# A d d e n d u m

<b>B.O.</b>	<b>Proposal ID</b>	<b>Proposal Work Type</b>	<b>County</b>	<b>Project Number</b>	<b>Addendum</b>
012	78-1642-664-A	RCB CULVERT REPLACEMENT - SINGLE BOX	POTTAWATTAMIE	BROS-1642(664)--8J-78	20JUN012A01

**9<sup>th</sup> & 10<sup>th</sup> Street Culvert Replacement**

**Project No: BROS-1642(664)--8J-78**

STEEL CASING PLACEMENT DETAIL  
NO SCALE

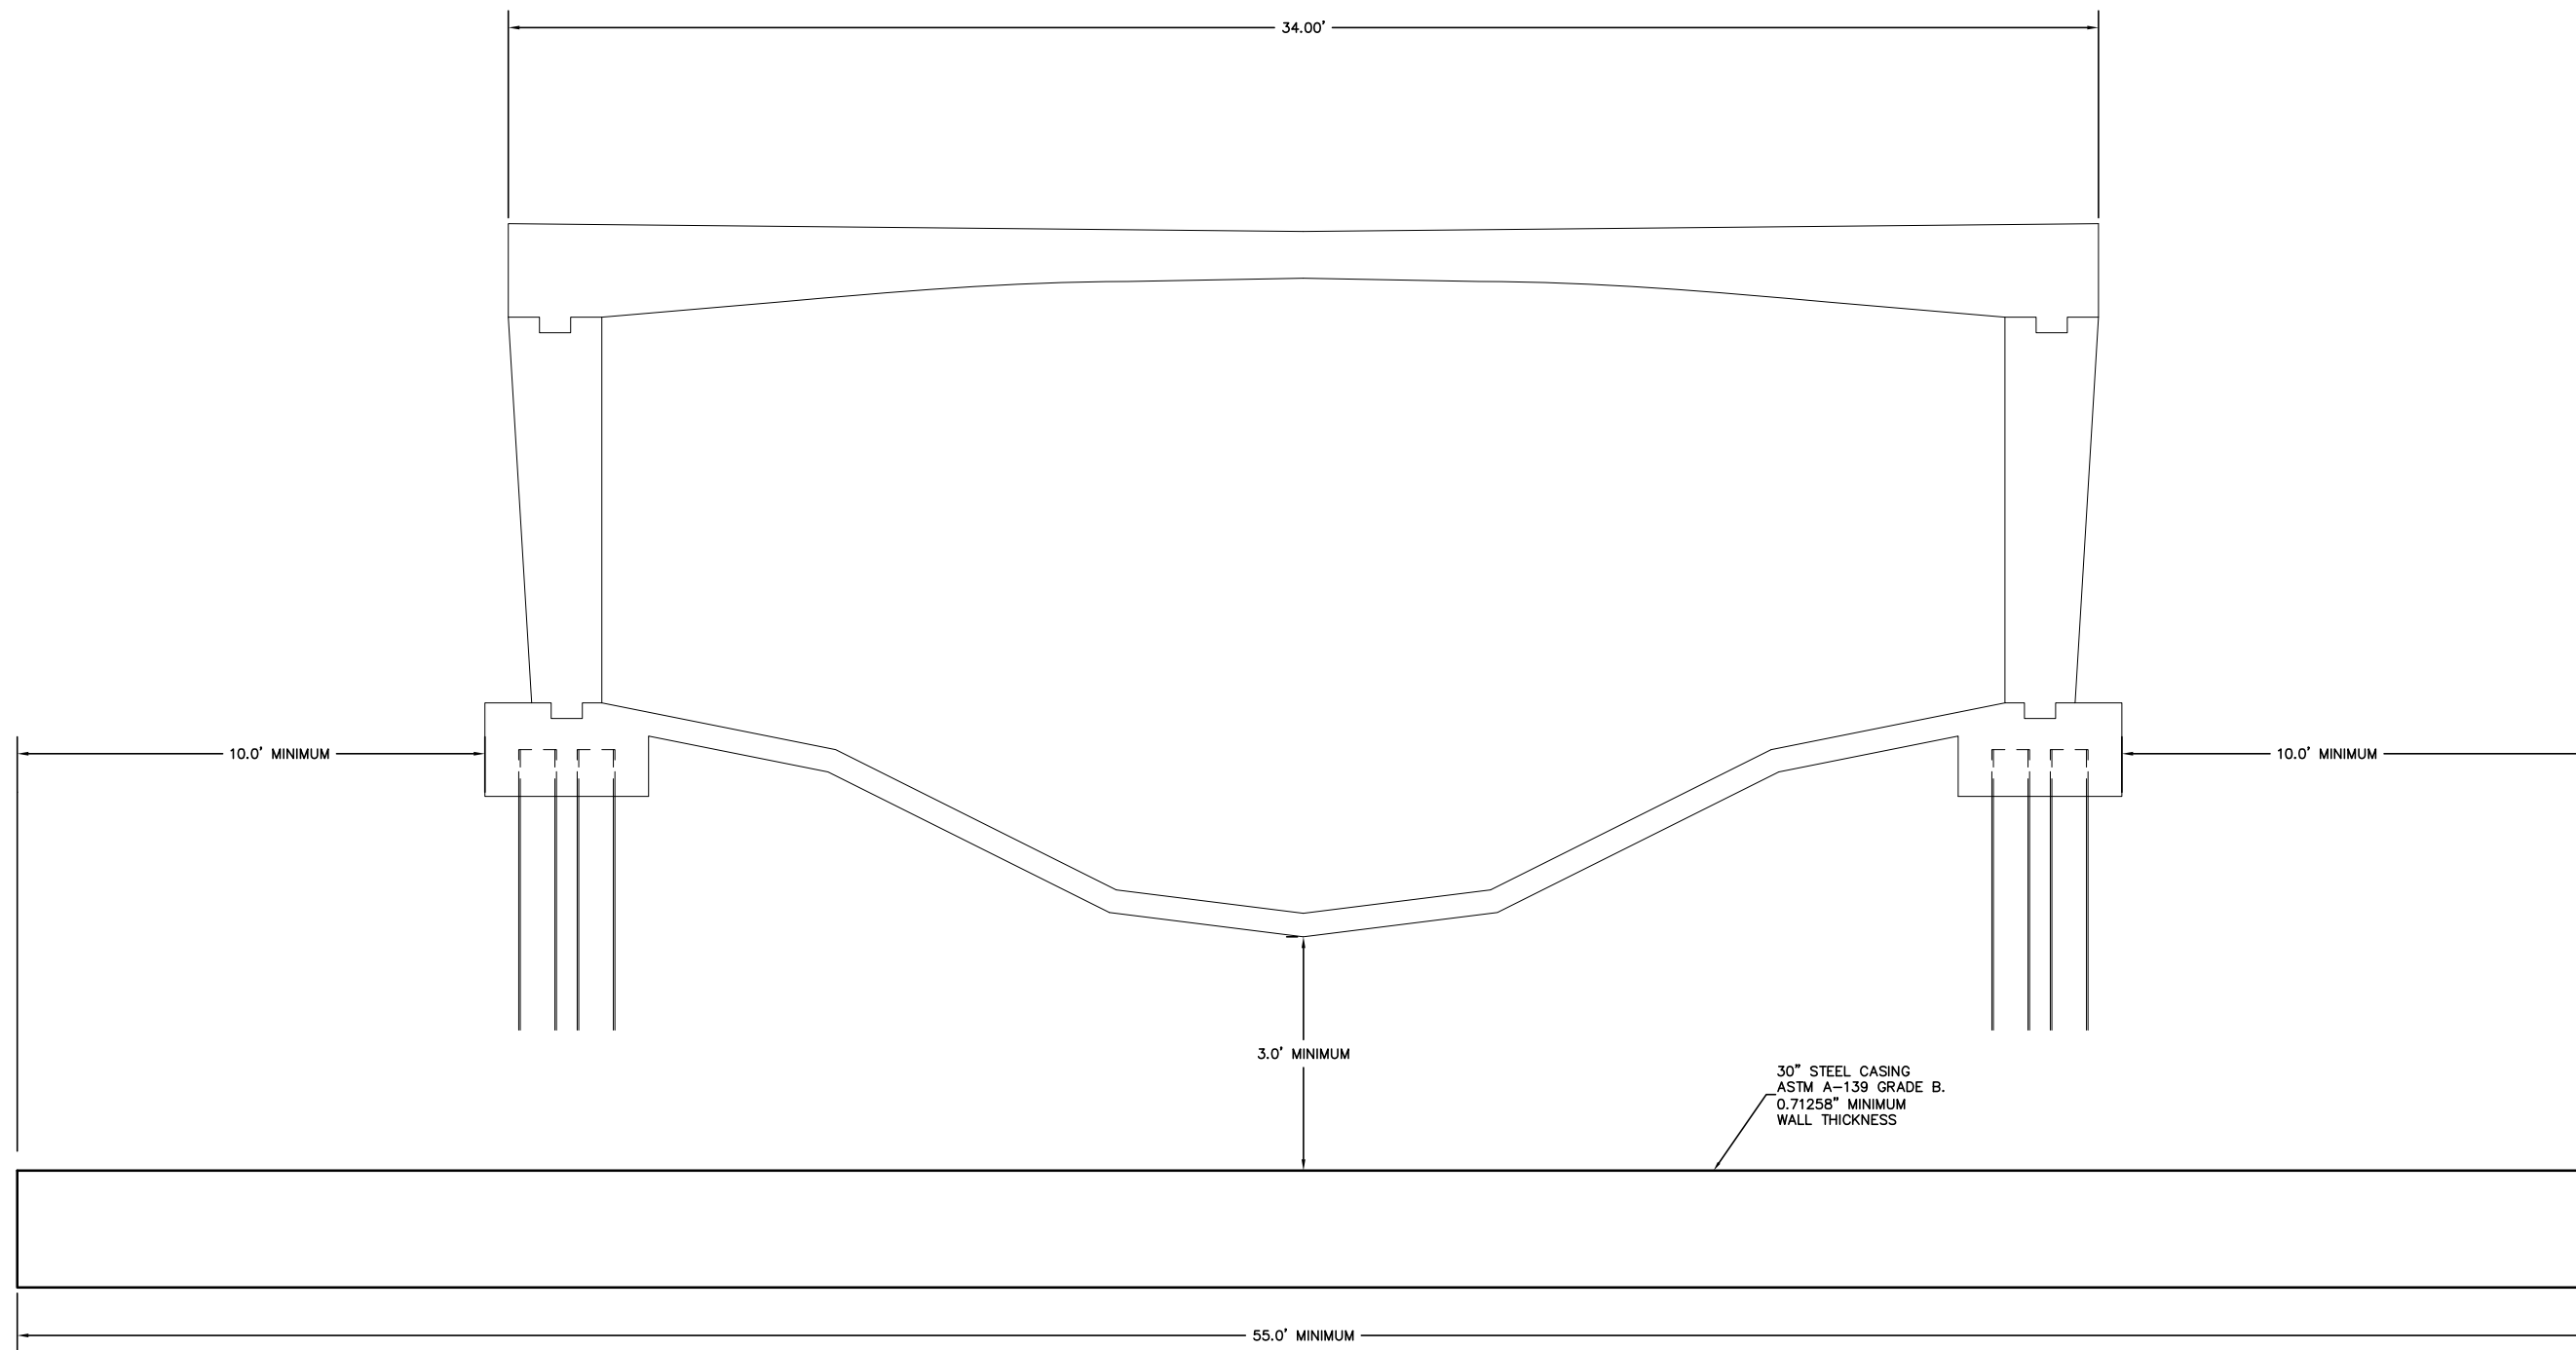
Replace plan sheets C.02 and M.01 with the attached.

Plan Sheet M.01; Changed the minimum clearance.

40.	2599-9999010	STEEL CASING, 30" REFER TO SHEETS D.01 AND M.01. CONTRACTOR SHALL PERFORM ALL REQUIRED EXCAVATION, DEWATERING, BACKFILLING, COMPACTION AND SURFACE RESTORATION REQUIRED FOR THE COUNCIL BLUFFS WATER WORKS TO SELF-PERFORM THE ABANDONMENT OF THE EXISTING WATER MAIN THROUGH THE CONSTRUCTION LIMITS. CONSTRUCT THE NEW WATER MAIN AND CONNECTIONS OF THE NEW WATER MAIN TO THE EXISTING WATER MAIN. CONTRACTOR SHALL ALLOW 1 WORKING DAY FOR THE COUNCIL BLUFFS WATER WORKS TO SELF-PERFORM THE ABANDONMENT OF THE EXISTING WATER MAIN. CONTRACTOR SHALL IDENTIFY THE LIMITS OF THE REQUIRED WATER MAIN ABANDONMENT TO THE COUNCIL BLUFFS WATER WORKS PRIOR TO THE PRECONSTRUCTION MEETING. CONTRACTOR SHALL PROVIDE AND INSTALL 55.0' 30" STEEL CASING, ASTM A-139 GRADE B, 0.71258" MINIMUM WALL THICKNESS, VIA TRENCHED OR TRENCHLESS INSTALLATION METHODS. CONTRACTOR SHALL INSTALL DUCTILE IRON WATER MAIN AND CASING CHOCKS WITHIN THE CASING. THE DUCTILE IRON WATER MAIN AND CASING CHOCKS WILL BE PROVIDED TO THE CONTRACTOR BY THE COUNCIL BLUFFS WATER WORKS. CONTRACTOR SHALL COORDINATE THE INSTALLATION OF THE WATER MAIN WITHIN THE CASING WITH THE COUNCIL BLUFFS WATER WORKS, BRIAN CADY (712) 328-1006 EXT. 1039. CONTRACTOR SHALL PROVIDE ADEQUATE ACCESS, DEWATERING AND WORK SPACE AT BOTH ENDS OF THE CASING FOR THE COUNCIL BLUFFS WATER WORKS TO INSTALL ADDITIONAL WATER MAIN AND APPURTENANCES BEYOND THE CASING AND OUTSIDE OF THE CONSTRUCTION LIMITS. CONTRACTOR SHALL ALLOW FOR 11 CALENDAR DAYS AFTER INSTALLATION WITHIN THE CASING FOR THE COUNCIL BLUFFS WATER WORKS TO SELF-PERFORM THE REMAINING WATER MAIN INSTALLATION. THE COUNCIL BLUFFS WATER WORKS RESERVES THE RIGHT TO DELETE THIS WORK AND/OR SELF-PERFORM THIS WORK PRIOR TO CONTRACT AWARD. MEASUREMENT AND PAYMENT SHALL BE AT THE CONTRACT LUMP SUM PRICE FOR 30" STEEL CASING INSTALLED. BASIS OF PAYMENT SHALL BE FULL COMPENSATION FOR ALL MATERIALS, LABOR, TOOLS, AND EQUIPMENT NECESSARY TO COMPLETE THE WORK.
